CENTRAL LATHROP

DESIGN GUIDELINES

CENTRAL LATHROP DESIGN GUIDELINES AND MASTER SIGN PLAN ERRATA

The following amendments have been made to the Central Lathrop Design Guidelines and Master Sign Plan, dated November 9, 2004.

Exhibit 1: Multi-Tenant Freestanding (Monument) Sign Details

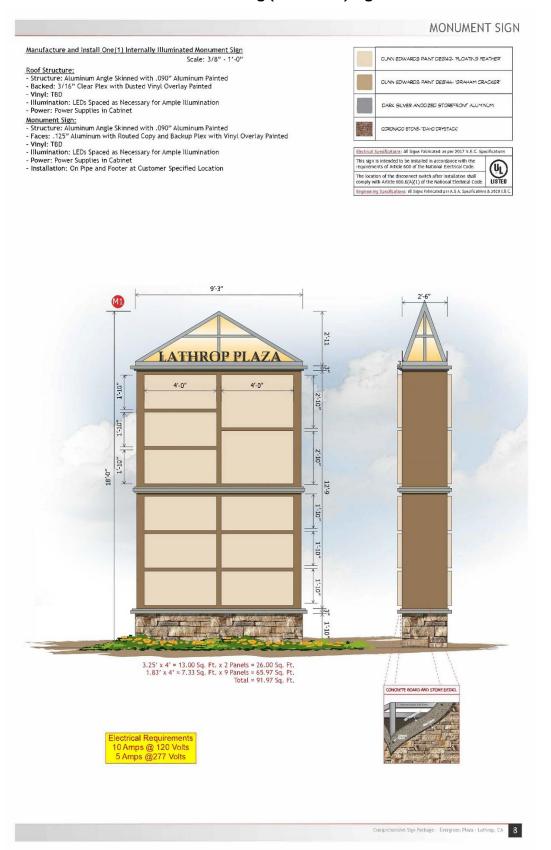
Central Lathrop Design Guidelines and Master Sign Plan							
Section	<u>Date</u>	Page Reference	Comment					
I.	Substantial Conformance Approval, dated March 25, 2025	5-24 5-27(A) 5-27(B)	Table 5-5: Permitted Freestanding Signs. Update the "Individual Use and Building Complex" section of the Office/Commercial Land Use District to regulate the location and design of the multi-tenant freestanding monument signs. Additional Sign Exhibits included.					
Section	Date	Page Reference	Comment					
II.	Substantial Conformance Approval, dated April 20, 2020	3-6	3.2.1: <i>Golden Valley Parkway.</i> Update Street Tree table to include five (5) varieties of Street Trees for this roadway.					
		3-10	3.2.2: <i>Lathrop Road.</i> Update Street Tree table to include four (4) varieties of Street Trees for this roadway.					
		3-20	3.2.4: <i>Collector Streets.</i> Update Street Tree table for "Street A" to include three (3) varieties of Street Trees for this roadway.

- 3. Each proposed Multi-Tenant
 Freestanding (monument) sign requires
 the completion of a Sign Design
 application which is subject to review
 and approval by the Central Lathrop
 Design Review Board (CLDRB):
- a) Prior to constructing such signs, a privately coordinated effort shall be made between the property owner(s) and future tenant(s) to set up the construction and maintenance of these signs.
- b) In the event a tenant vacates a sign panel position from the Multi-Tenant Freestanding (monument) sign, the owner(s) of the Multi-Tenant Freestanding (monument) sign shall be responsible for maintaining said vacated sign area.
